PART - GROUP CHANGE NOTIFICATION		Bulletin no:2010-12		01.03.2010
arçelik	**Prepared by** Faruk TAN/Özlem Öztürk ÖZTAN		Signature		
	Approved by Sezgin PARMAKSIZ				
	Copy to	TH-YPLB	ÇMİ-MTk1	ÇMİ-ÜPB	ÇMİ-MÜT
		ÇMİ-KGB	ÇMİ-MTk2	ÇMİ-MTk3	Other ....

| Issue	The transition of the thermique cable socket to RAST5 in BLDC product

INSTALLATION METHOD

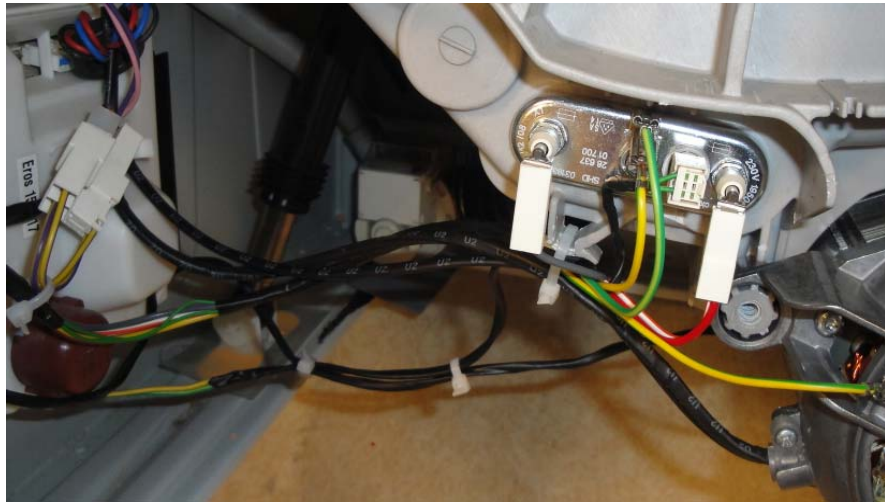
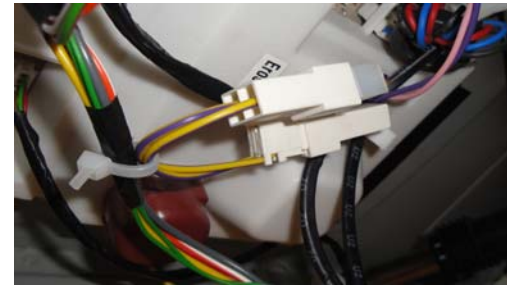
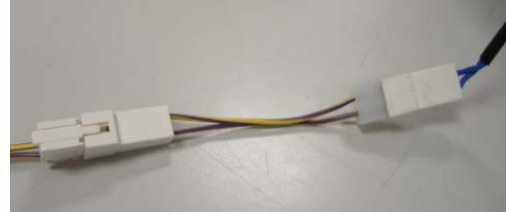
-For the BLCD products; an additional cable has been defined as in the new thermique cable RAST5 IDC socket is used.

-**In the combination of new and old motor** additional cable 274700200 will be used.

-**In the combination of old and new motor** aditional cable 274700100 will be used.

-Cables and motors will be send together for a while, if after sale service is needed.

-In case of the motor service cable; 2714700200 additional cable

-In case of the service of the main cable; 2714700100 additional cable

shall be submitted together for a while
